13 GREENHOUSE GAS

13.1 ASSESSMENT AND MITIGATION

Figure 13.1 Predicted greenhouse gas emission sources for the proposed expanded operation

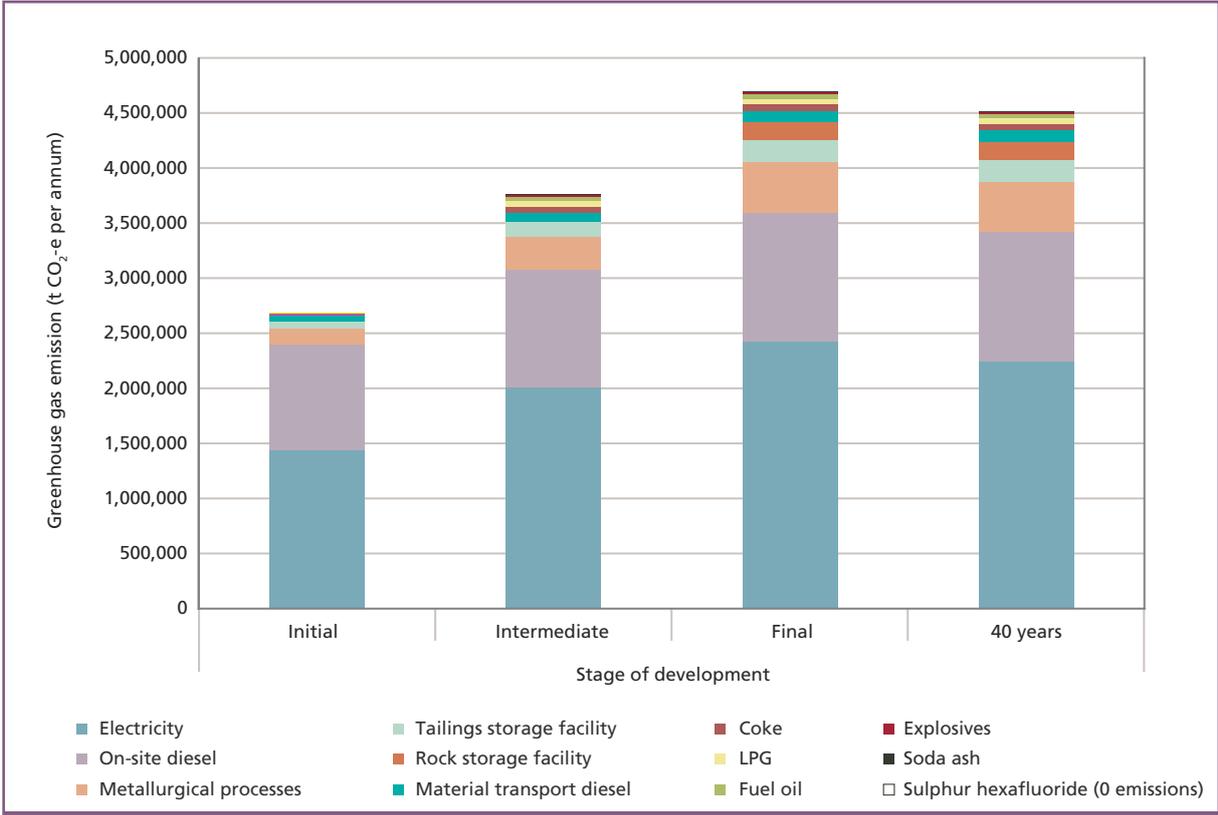
Clarification of the greenhouse gas (GHG) assessment presented in the Draft EIS was requested and additional information was sought on:

- the inclusion of embedded energy (life cycle) emissions sources
- sensitivity analysis of the key variables that influence operational GHG emissions
- energy efficiency opportunities and GHG mitigation commitments
- clarification of the baseline (1990) emission levels and proposed emissions trajectory
- comparison of proposed Olympic Dam emissions to those of other similar operations.

As presented in Figure 13.4 of the Draft EIS, and reproduced here as Figure 13.1, the primary contributors to the expanded operation's greenhouse gas emissions are the consumption of purchased electricity and on-site diesel, principally for use in the open pit mining fleet (see Figure 13.2 of the Supplementary EIS).

The approach adopted throughout the Draft EIS was to assess realistic worst-case conditions, and as such the electricity and diesel demand, and therefore the calculated GHG emissions, are considered upper boundaries. For example, the electricity consumption used for the GHG calculations was based on maximum, rather than average, demands from all electrical loads. Similarly, the diesel usage was based on the maximum mining fleet numbers (the mining fleet would be the largest consumer of diesel for the proposed expansion). Therefore, in terms of sensitivity analysis, the GHG calculations provided in the Draft EIS and the Supplementary EIS are conservative, and actual emissions are likely to be lower.

Figure 13.5 The nuclear fuel cycle

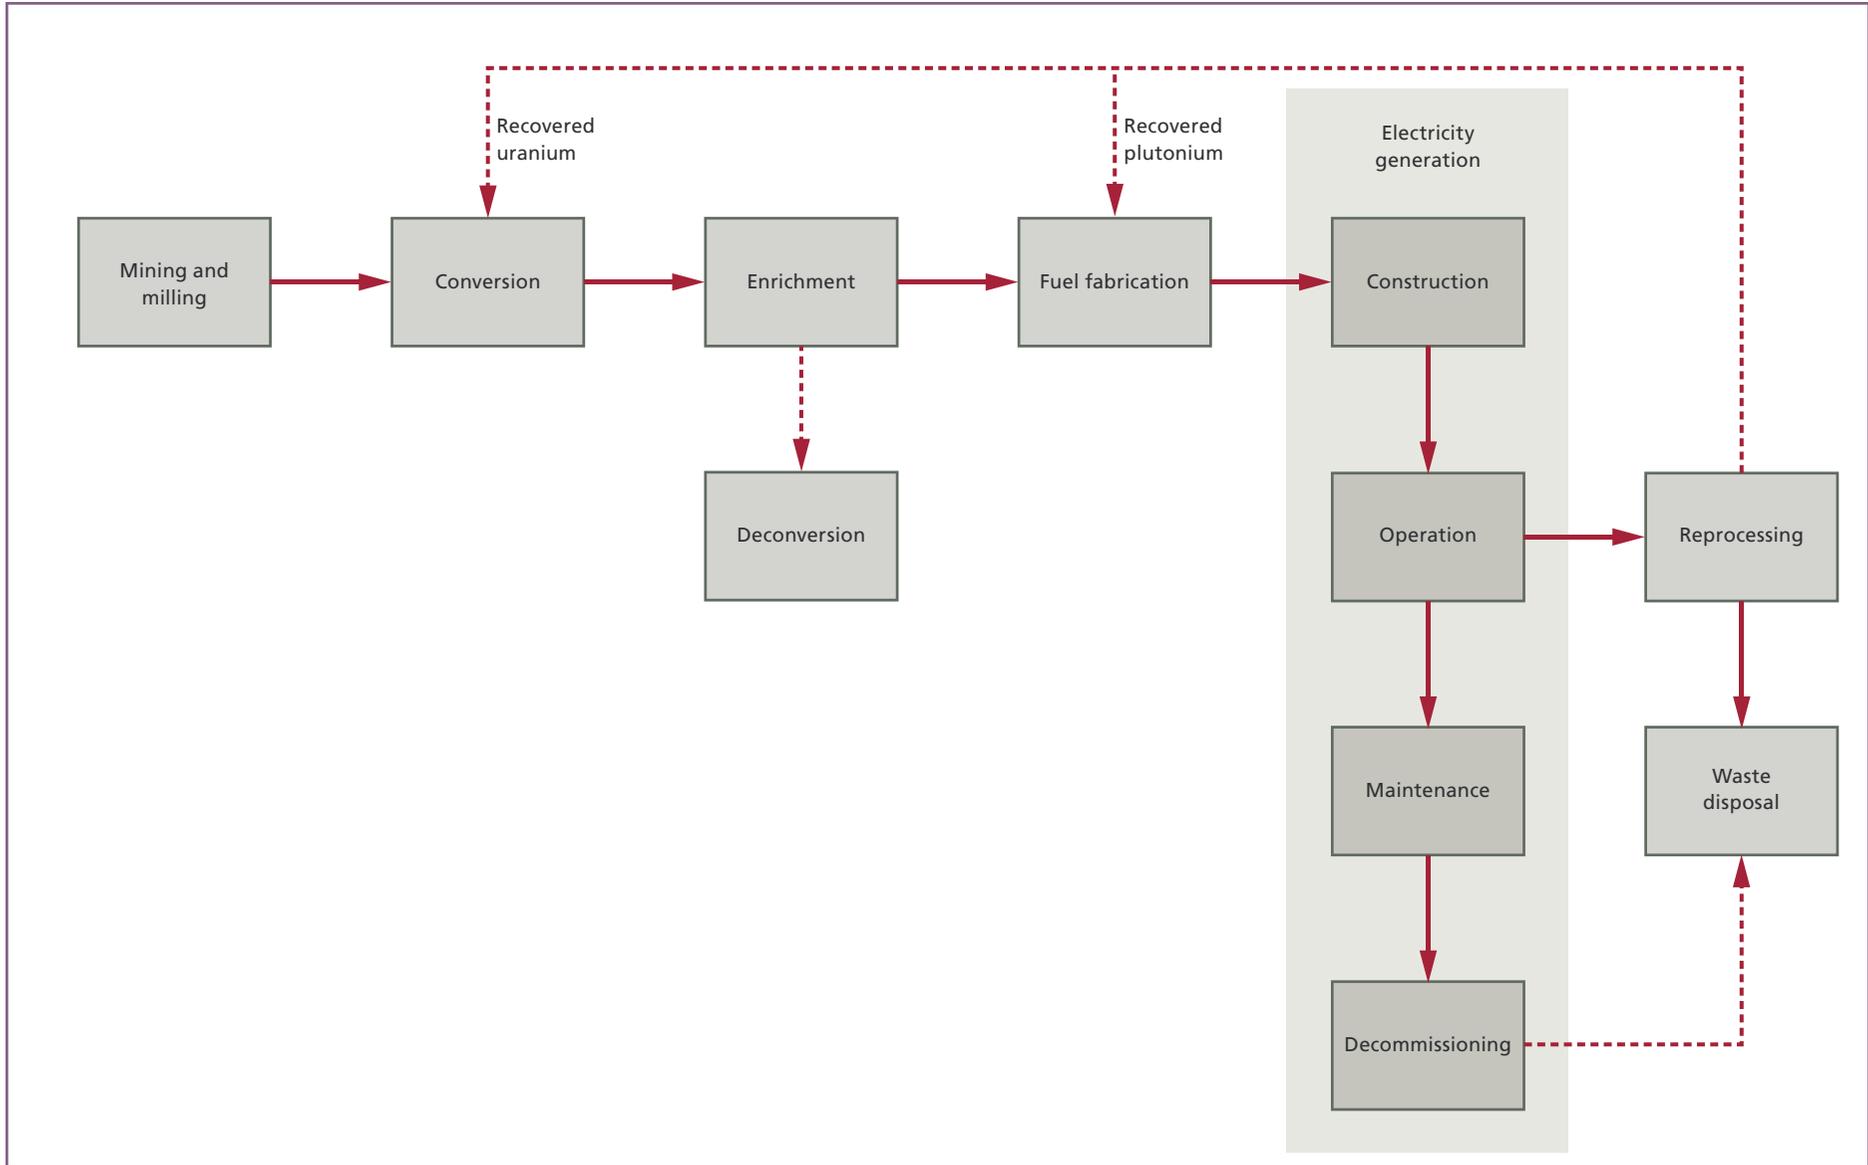
Further information was requested regarding the life cycle GHG implications of producing uranium and the life cycle costs of nuclear energy versus traditional fossil fuel and renewable energy sources. In addition, concerns were raised regarding the ability to meet state and federal emissions reduction targets in the context of the increased emissions associated with the proposed expansion. Clarification was sought regarding the potential impacts of the proposed emissions trading scheme (ETS), carbon pollution reduction scheme (CPRS) and the mandatory renewable energy target (MRET) on GHG emissions from an expanded Olympic Dam.

Details of the nuclear fuel cycle were presented in Section 2 of Appendix E3 of the Draft EIS, and are summarised here in Figure 13.5. Studies of nuclear fuel life cycle greenhouse gas emissions have shown that the generation of nuclear electricity produces about 65 g of CO₂-e per kWh of electricity generation (Sovacool 2008; Lenzen 2008). This emissions intensity is about 10 to 15 times less than that of fossil fuel electricity generation and at the higher end of the range of renewable electricity generation emission intensities.
